IREDELL COUNTY HEALTH DEPARTMENT

IMPROVEMENT PERMIT / AUTHORIZATION TO CONSTRUCT / OPERATION PERMIT / EXISTING SYSTEM INSPECTION

PERMIT# 122554 PIN# 4639-64-0340.050 DATE 3/22/07

SUBDIVISION Northgate Woods BLOCK / SECTION _____ LOT 30 LOT AREA 1.35 Acre SITE CLASS. PS DESIGN FLOW 450 L.T.A.R. .5

INITIAL SITE SKETCH

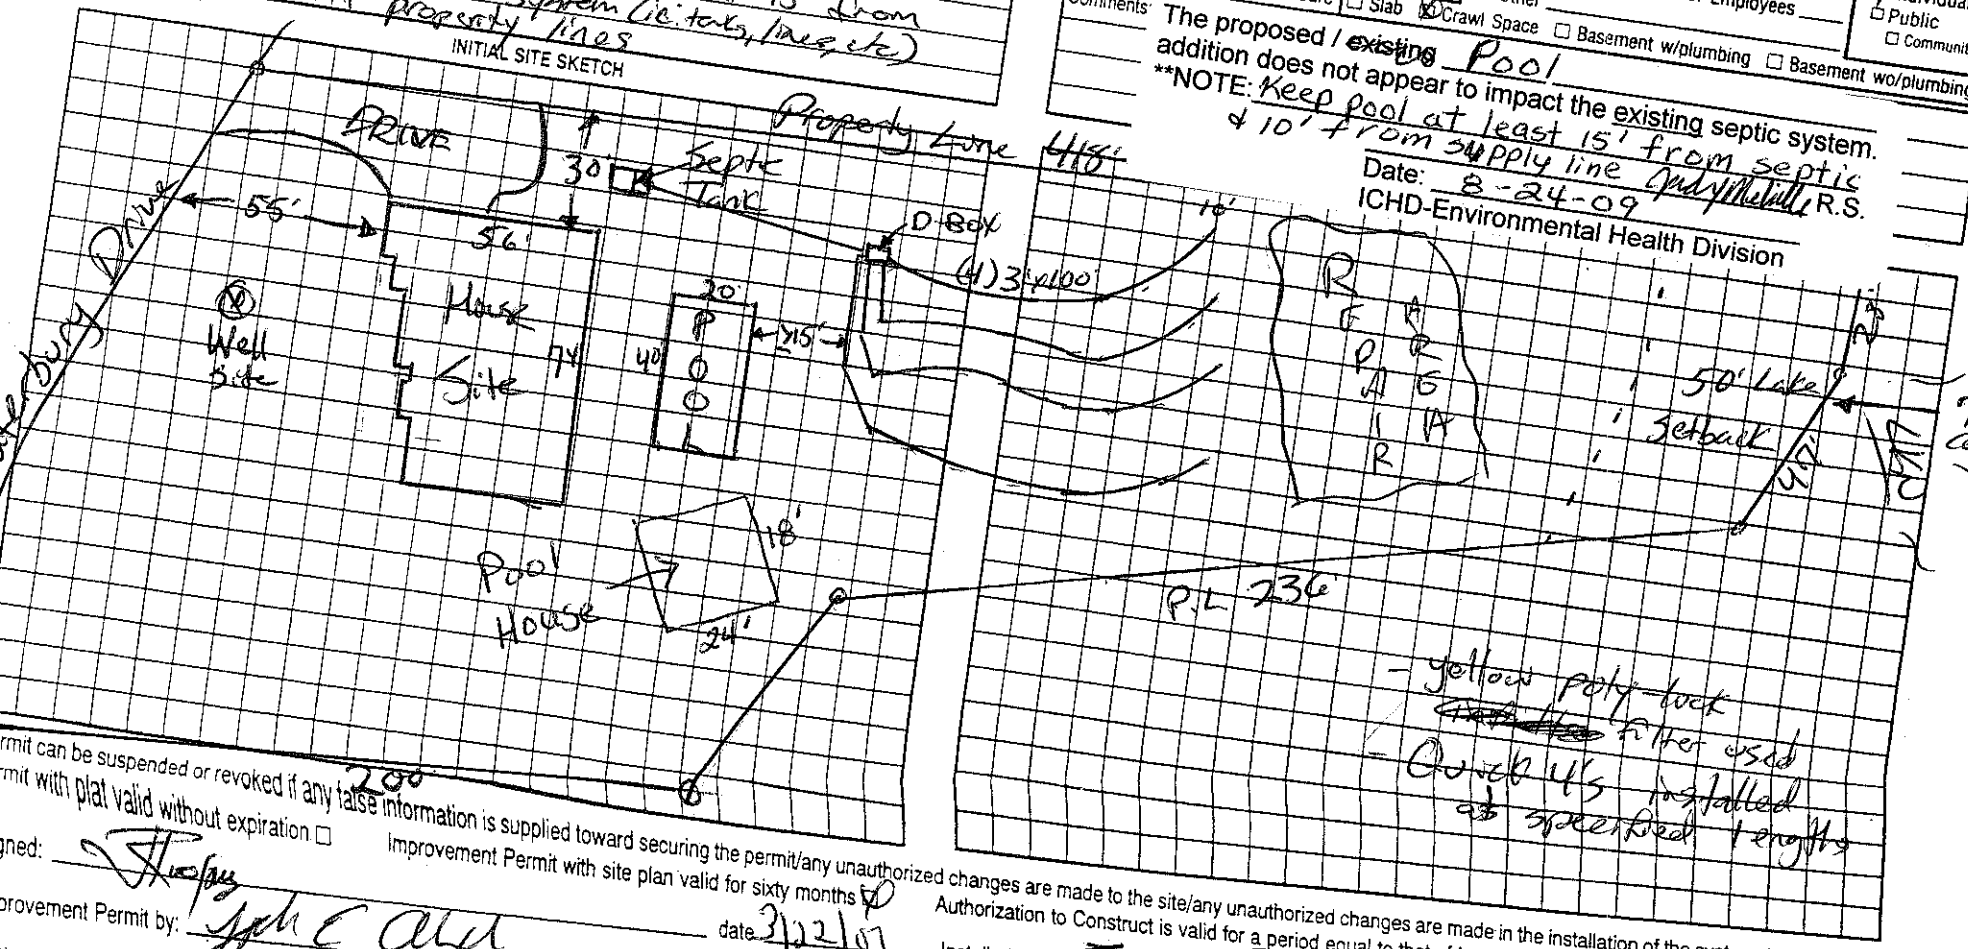
Comments/Conditions: 1) Install Lines on contour
2) Pool cut to be a MINIMUM of 15' from any and all parts of system (i.e. tanks, lines, etc)
3) Stay 10' off property lines

Comments: The proposed / ~~existing~~ Pool addition does not appear to impact the existing septic system.
**NOTE: Keep pool at least 15' from septic & 10' from supply line

AS BUILT SKETCH

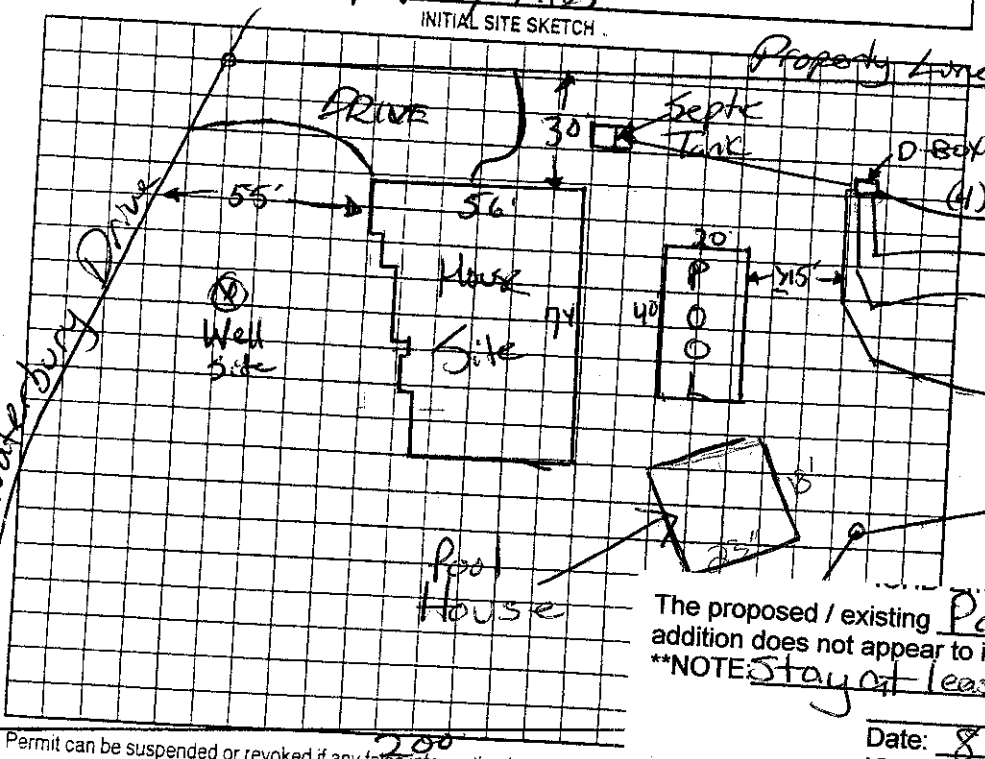
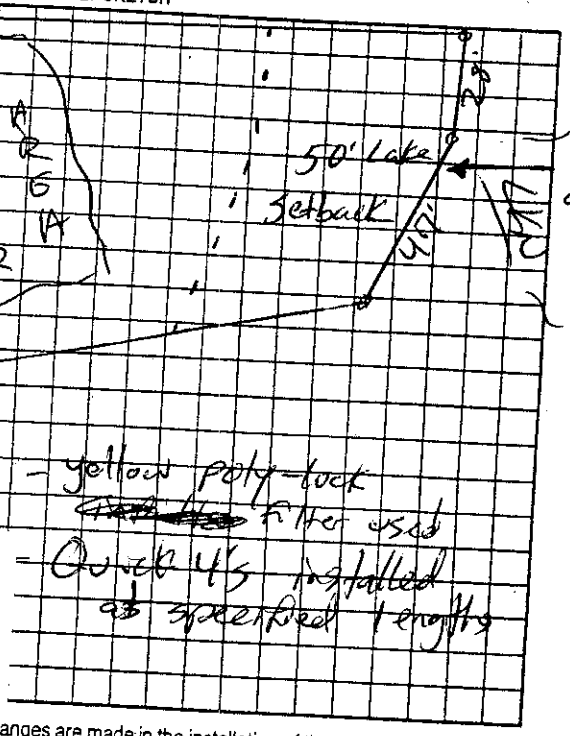
Comments/Conditions: 1) Install Lines on contour
2) Pool cut to be a MINIMUM of 15' from any and all parts of septic system (ie tanks, lines, etc)
3) Stay 10' off property lines

The proposed / existing Pool House addition does not appear to impact the existing septic system.

**NOTE: Stay at least 10ft from PL
